WINDERMERE PRELIMINARY PLAN

$E^{1/2}$ OF SECTION 29, T13S, R65W OF THE 6TH P.M. EL PASO COUNTY, COLORADO

WINDERMERE METRO DIST. COUNTY FILE NO.: SP-19-003 | SHEET: 1 OF 10

SP19003-V2-PrelimPlan redlines.pdf Markup Summary 8-20-2020

PP02

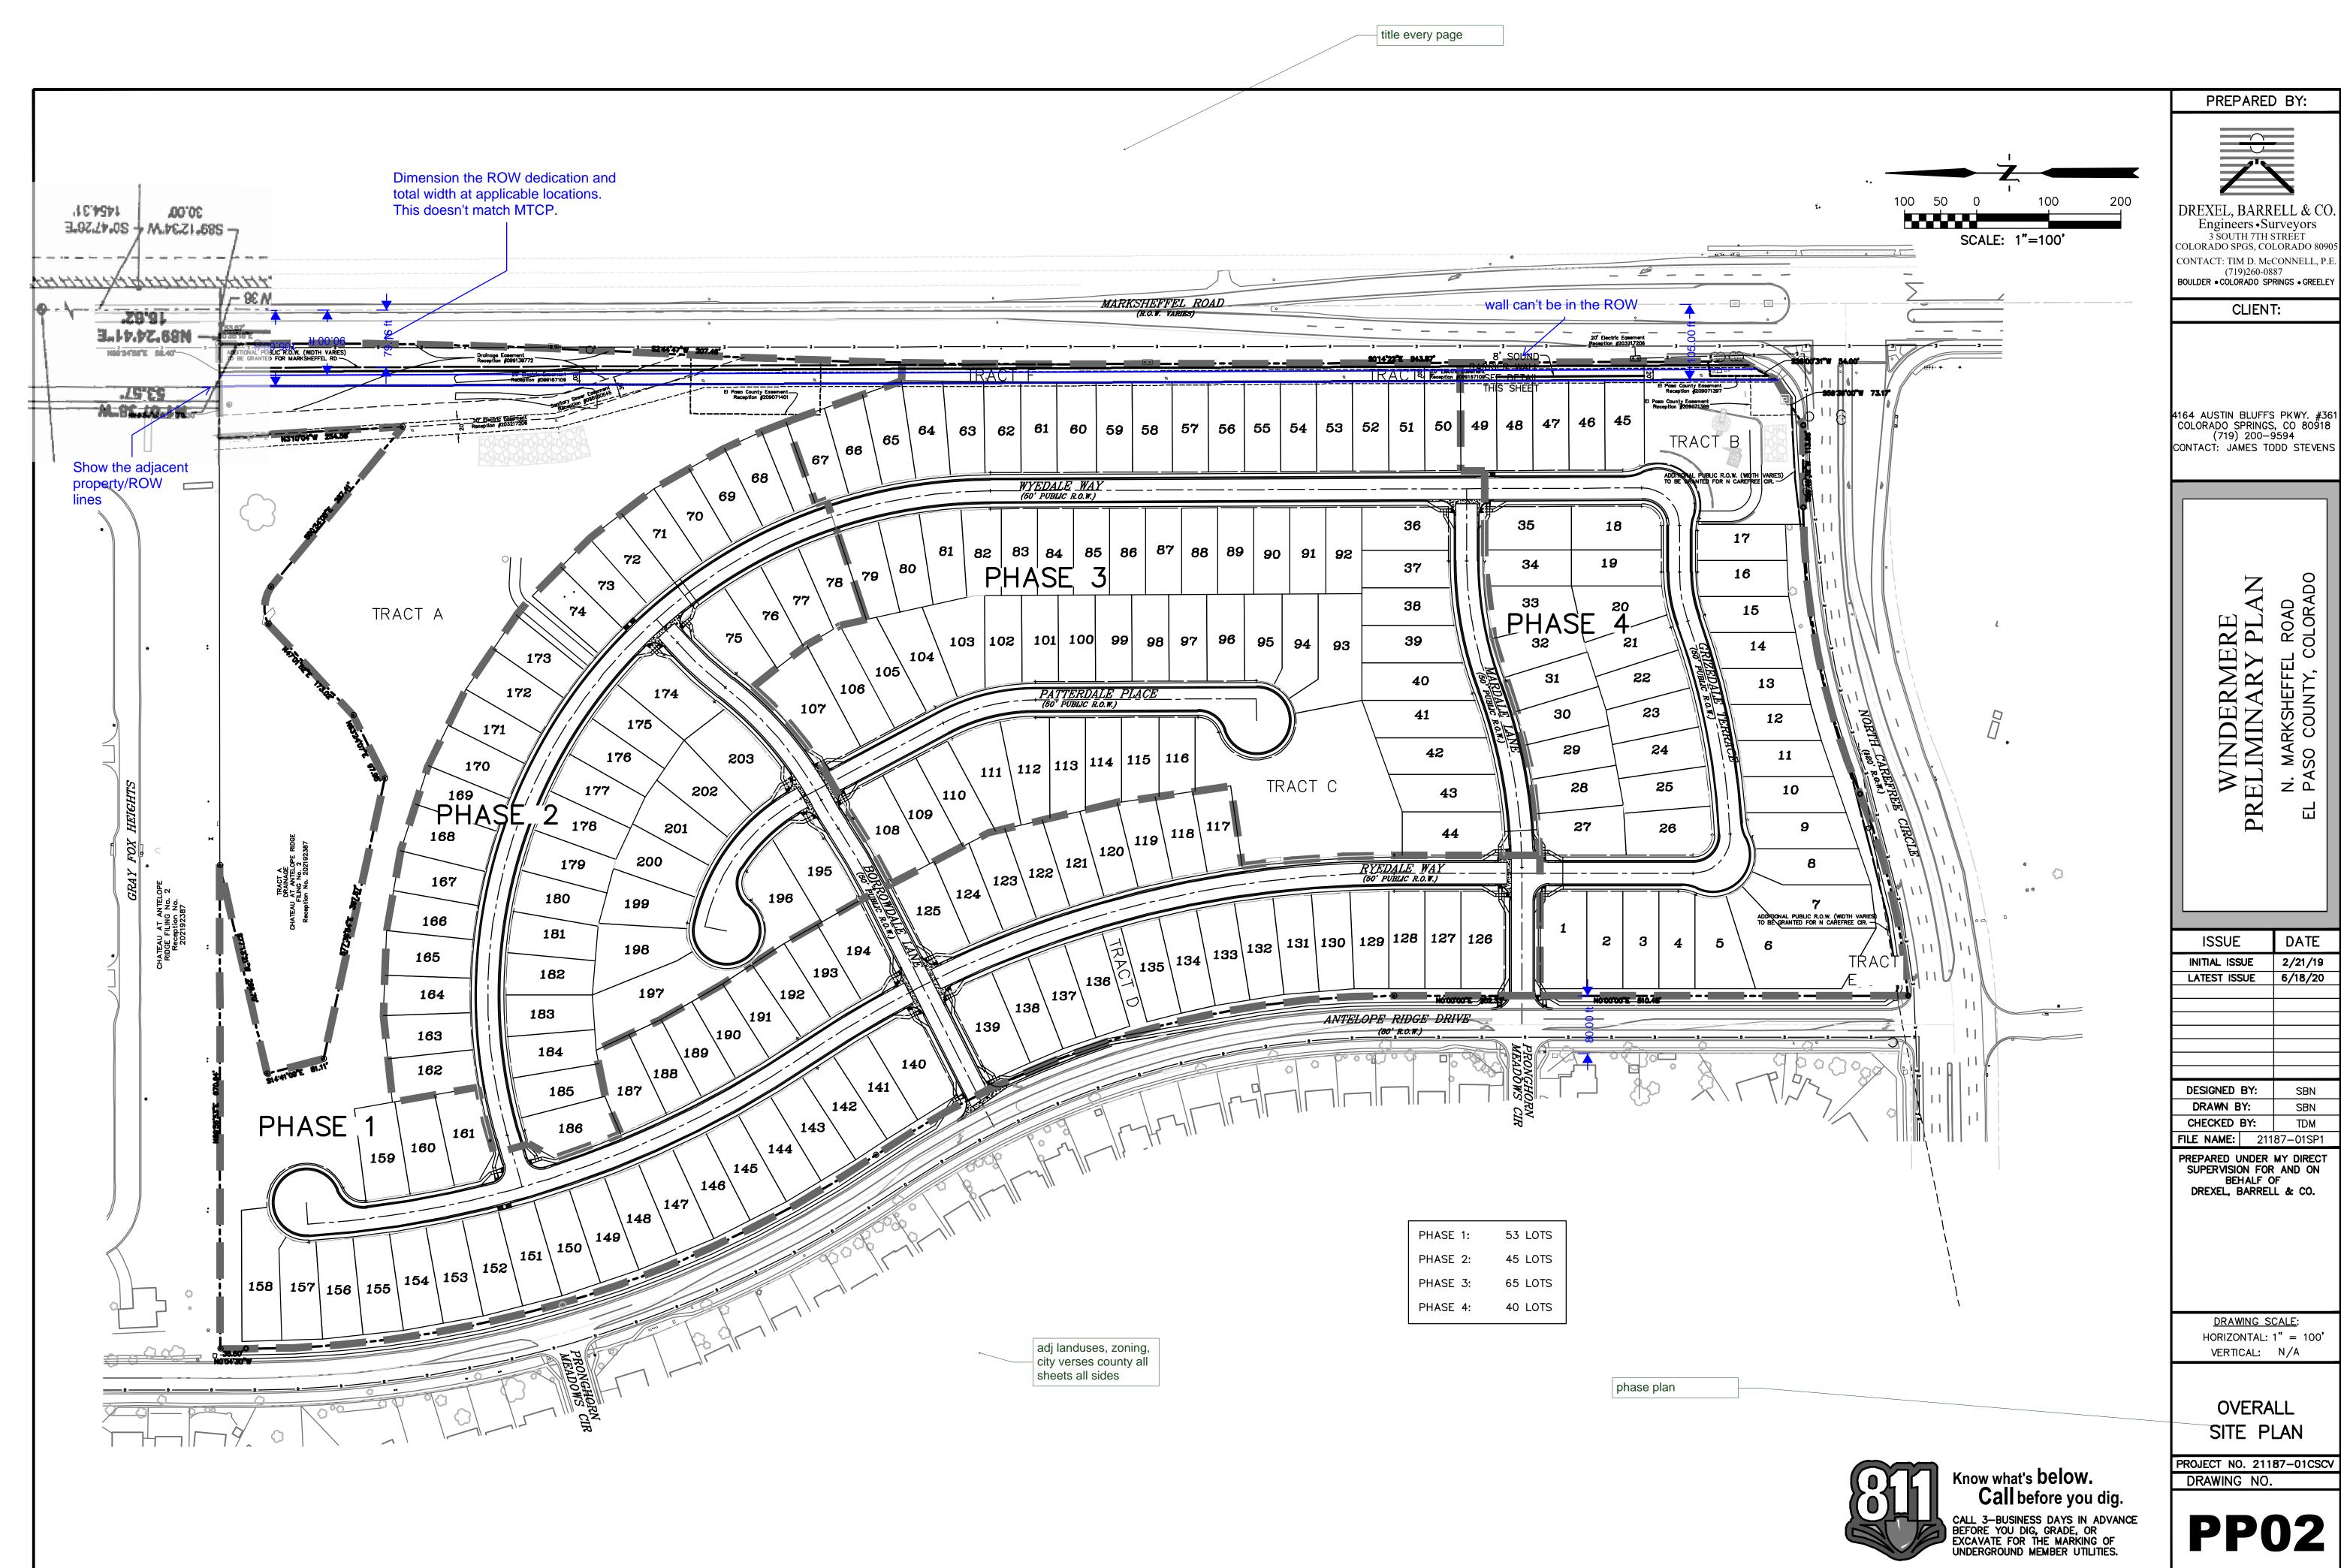
Split the ROW out and show as dedication.

title every sheet

COUNTY FILE NO.: SP-19-003 SHEET: 2 OF 10

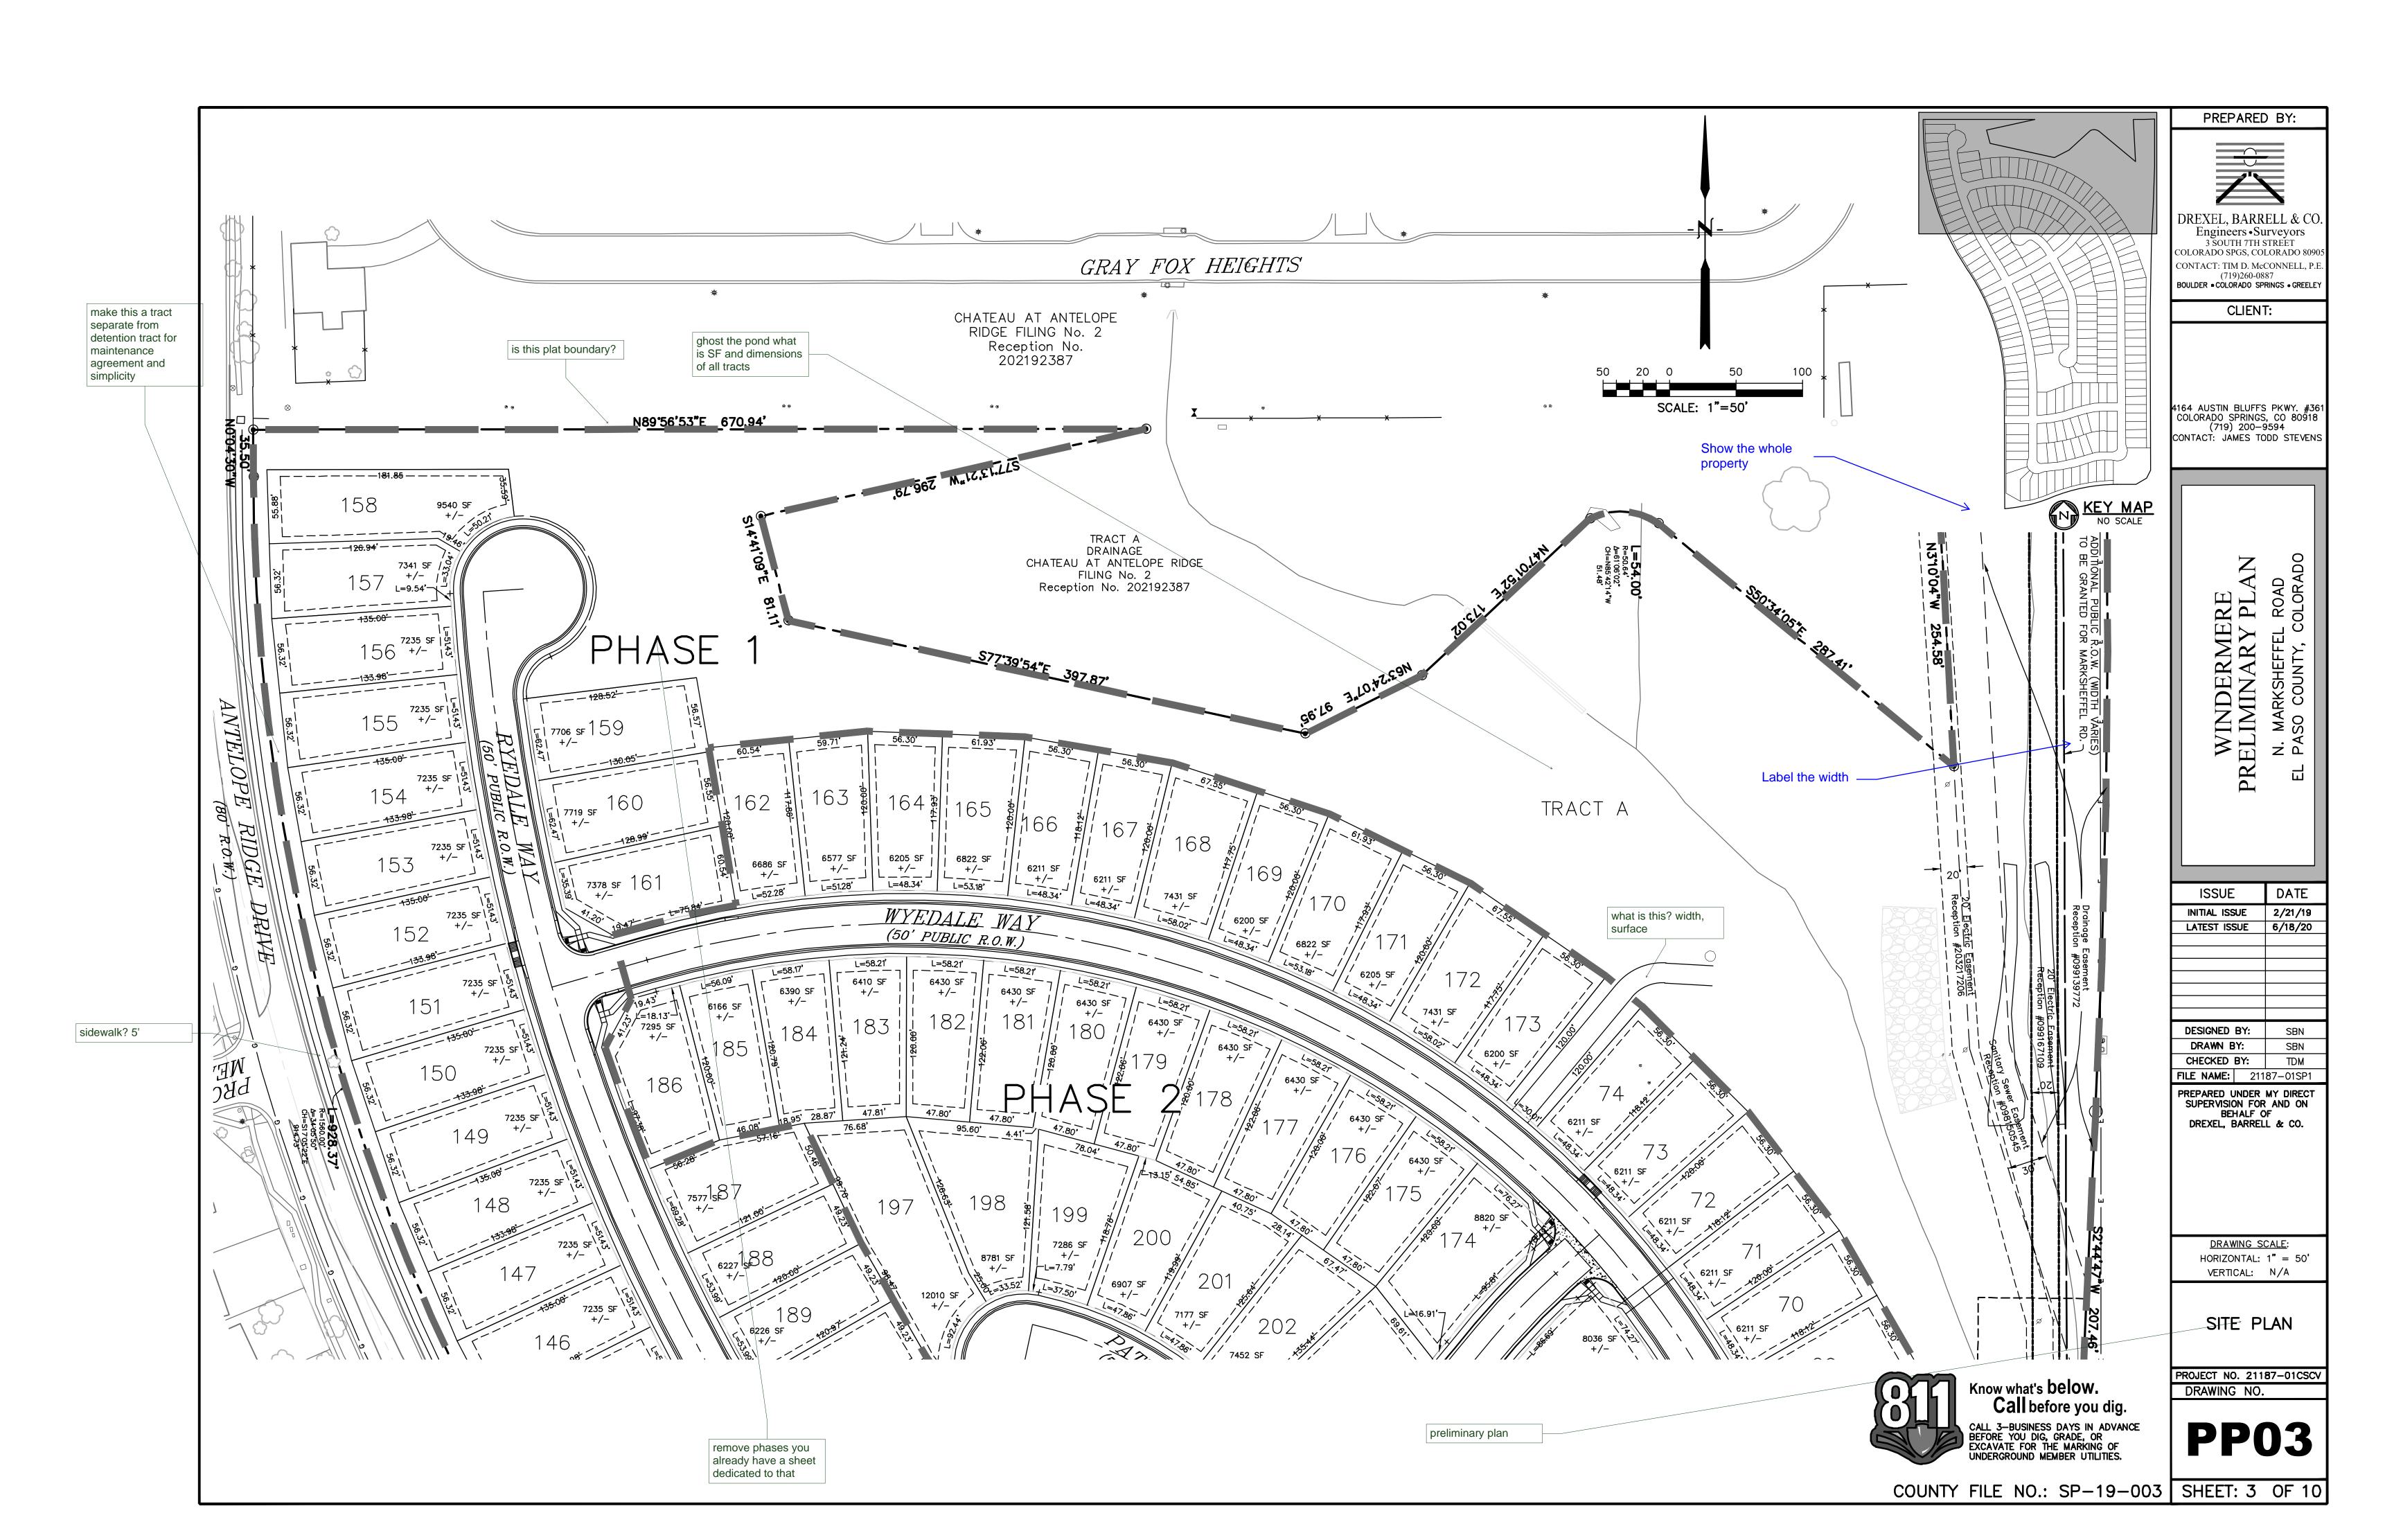
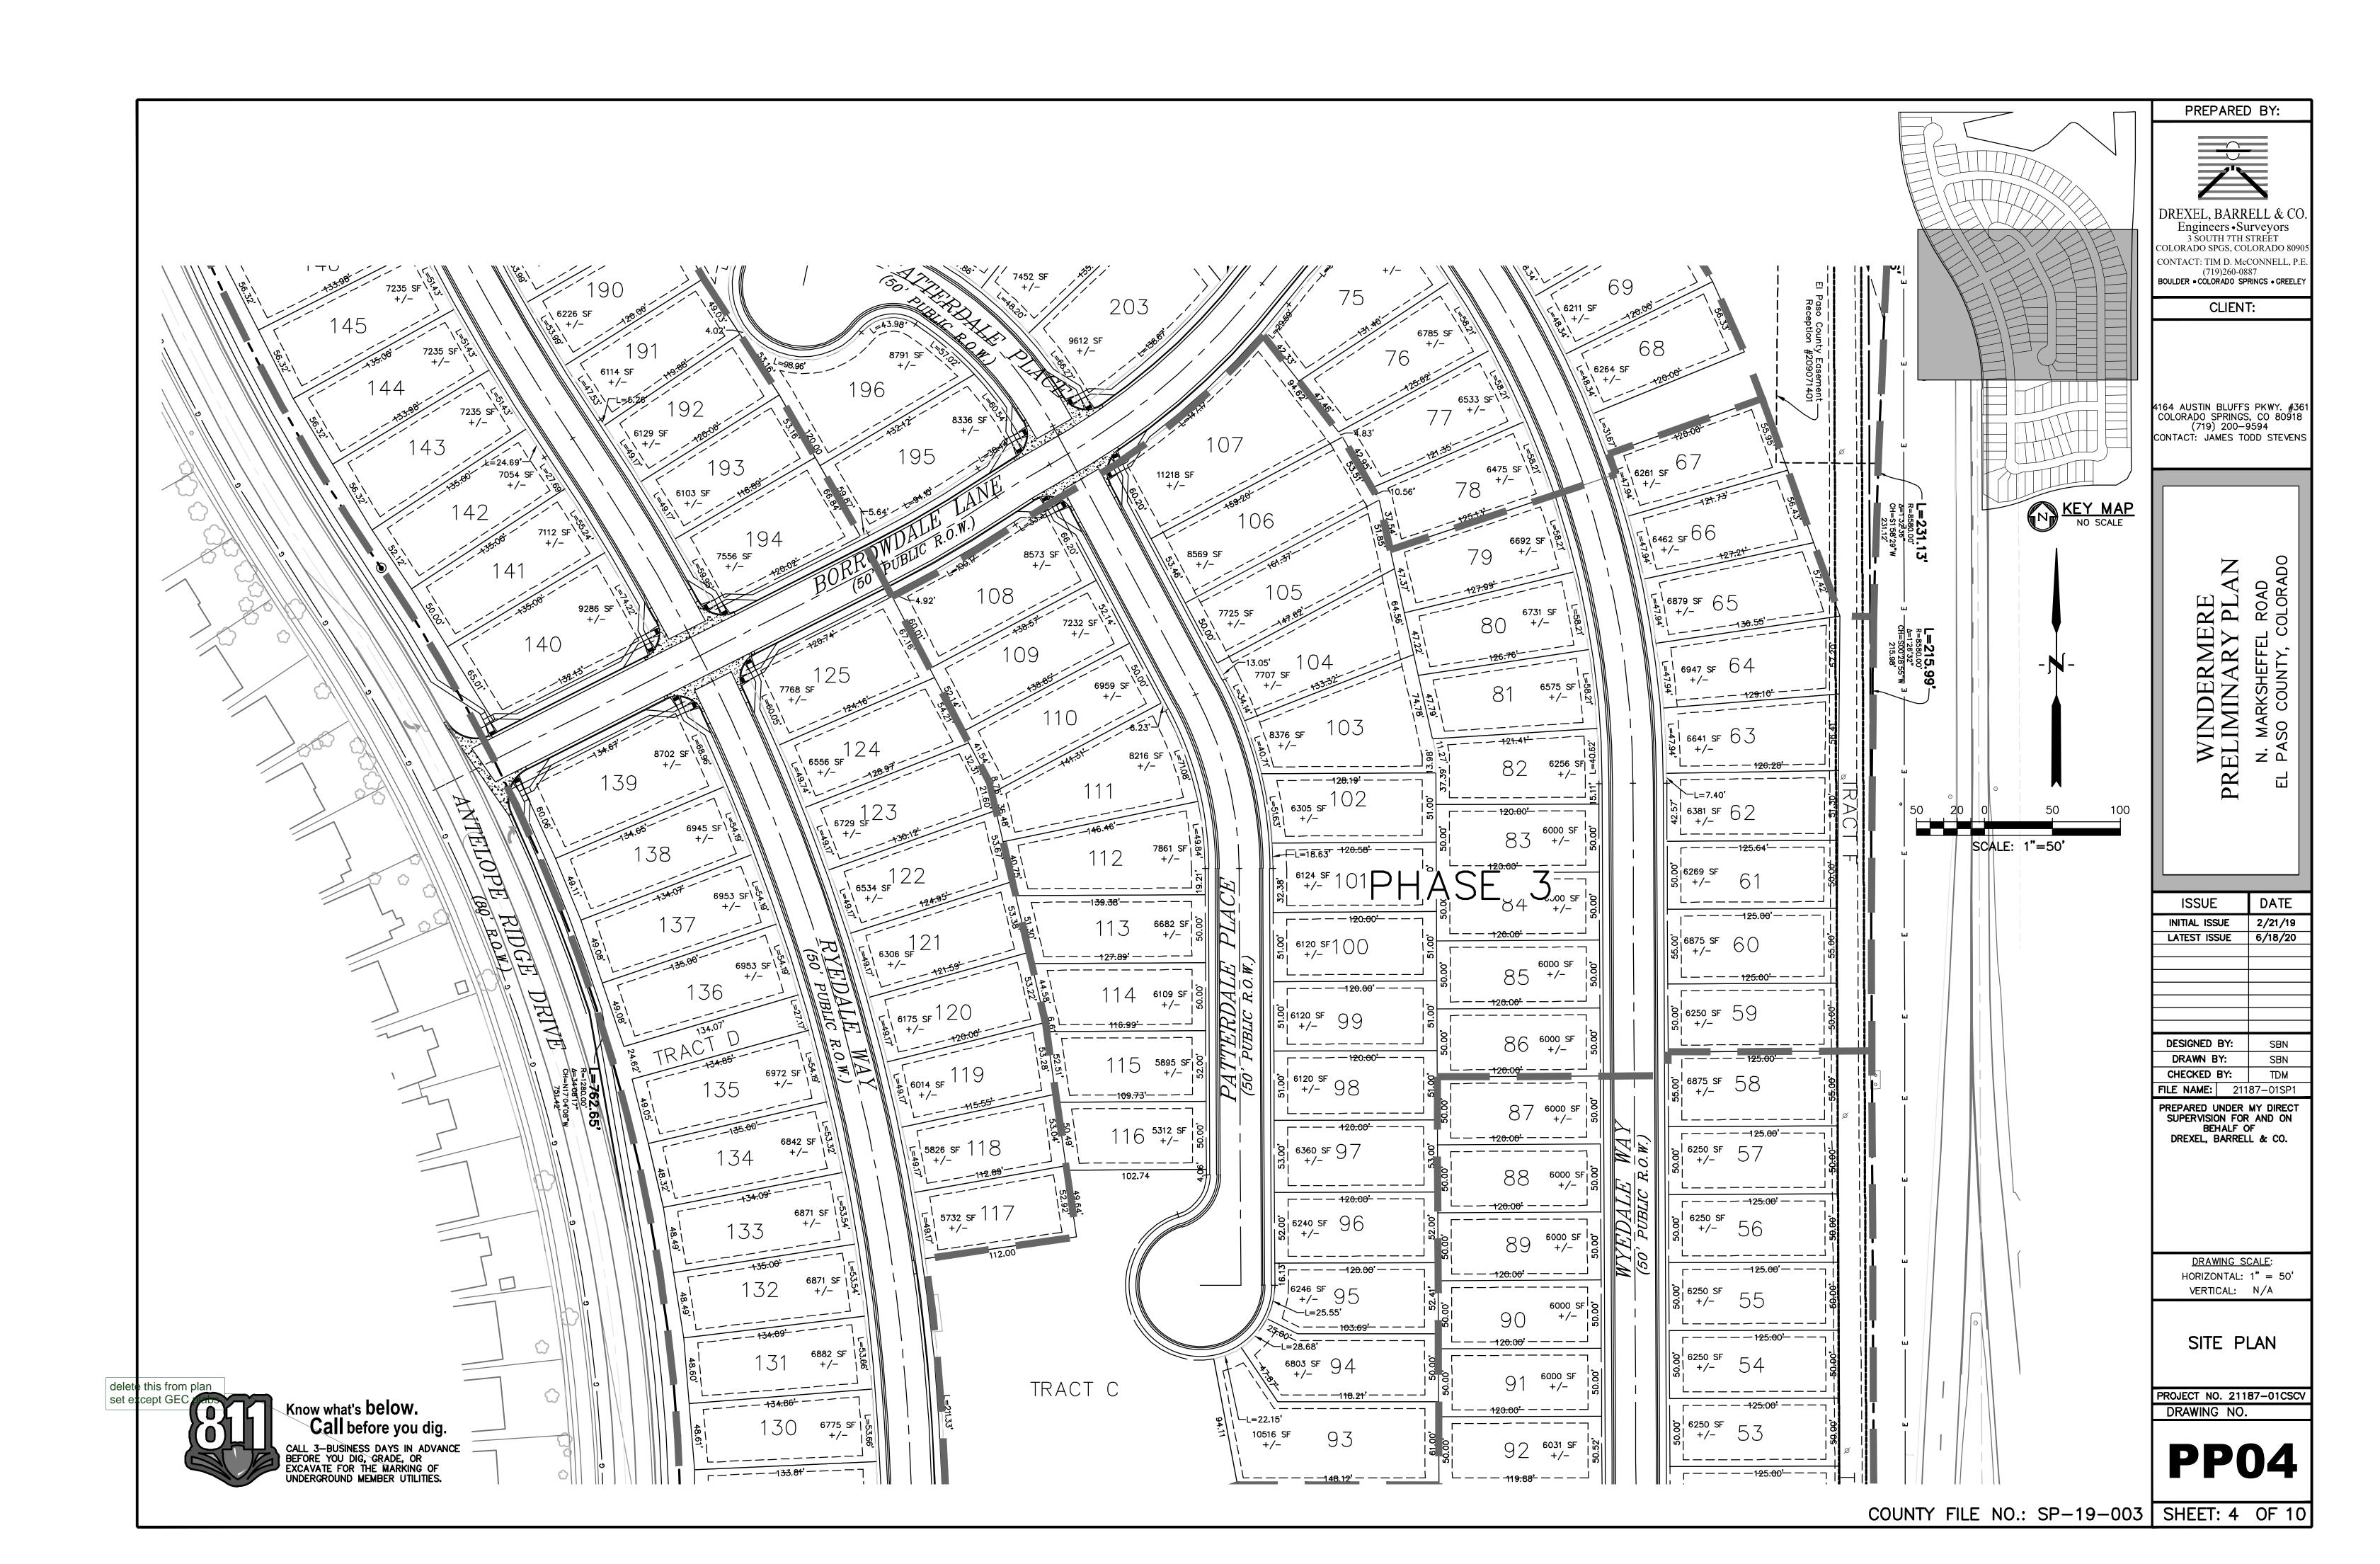
Status: Color: Layer: Space: Show the adjacent property/ROW lines

Status: Color: Layer: Space: wall can't be in the ROW

Status: Color: Layer: Space: Dimension the ROW dedication and total width at applicable locations. This doesn't match MTCP.

Subject: Callout title every page Page Label: [2] 2 21187-01SP1 - SP1 Author: dsdparsons Date: 8/20/2020 5:03:46 PM Status: Color: Layer: Space: Subject: Callout phase plan Page Label: [2] 2 21187-01SP1 - SP1 Author: dsdparsons Date: 8/20/2020 5:04:05 PM Status: Color: Layer: Space: Subject: Callout preliminary plan Page Label: [3] 3 21187-01SP1 - SP2 Author: dsdparsons Date: 8/20/2020 5:04:19 PM Status: Color: Layer: Space: Subject: Callout phase plan Page Label: [1] 1 21187-01CV1 - DP01 Author: dsdparsons Date: 8/20/2020 5:04:42 PM Status: Color: Layer: Space: Subject: Callout preliinary plan Page Label: [1] 1 21187-01CV1 - DP01 Author: dsdparsons Date: 8/20/2020 5:04:53 PM

ROW Preservation?

ROW dedication?
